## Accessibility Survey

## City of Downey Verdura Avenue - Devenir Street To Imperial Highway

Devenir Street To Imperial Highway  
Downey, CA 90242

Date of Inspection  
3/17/2017

#### Change In Level South Of Imperial Highway @ 33.915788302432, - 118.144239485264

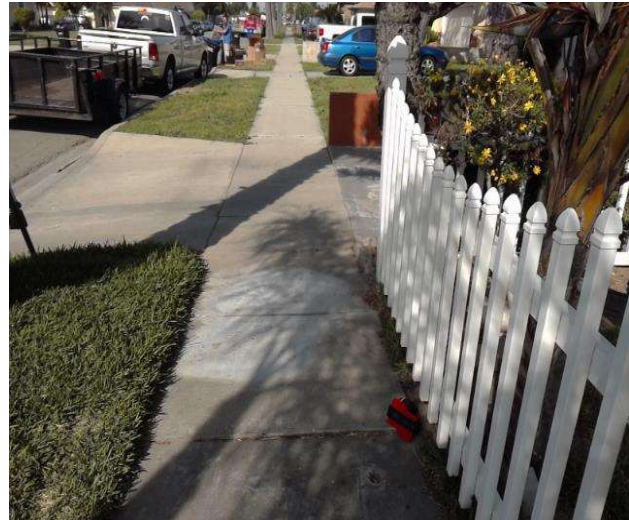
There is a change in elevation greater than recommended value.

**On-Site Finding** 0.87 inches

Ensure that the change in elevation is within the recommended value.

Recommendation Up to 0.25 inches

#### Change In Level South Of Imperial Highway @ 33.915881788254, - 118.144173771143

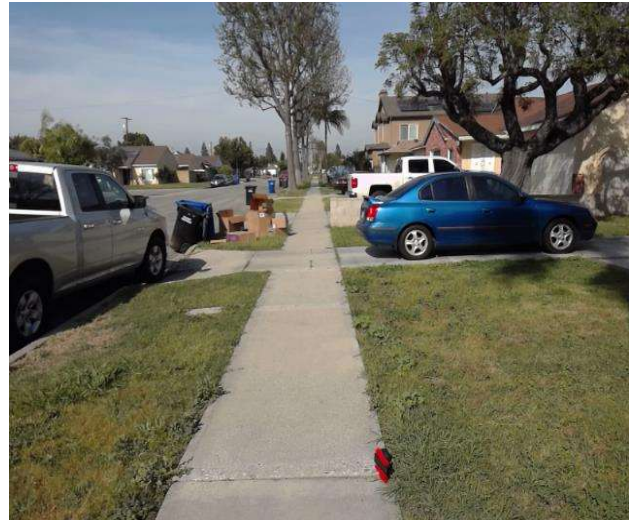
There is a change in elevation greater than recommended value.

**On-Site Finding** 0.62 inches

Ensure that the change in elevation is within the recommended value.

Recommendation Up to 0.25 inches

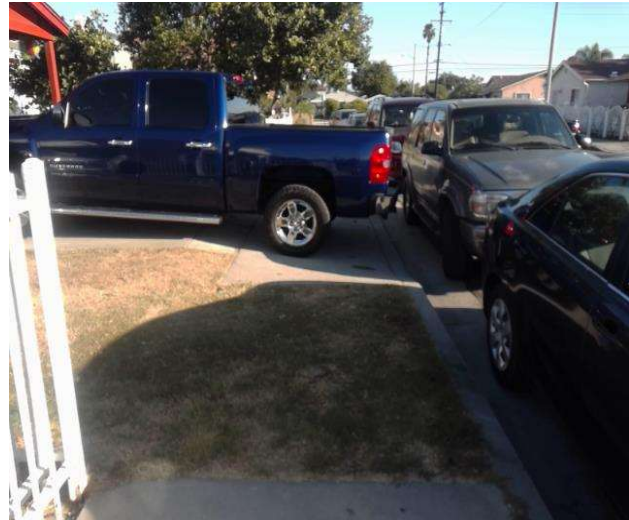
Section of sidewalk is missing and consists of dirt, grass or gravel.

**On-Site Finding** 9.00 feet

Provide a compliant sidewalk for the missing section.
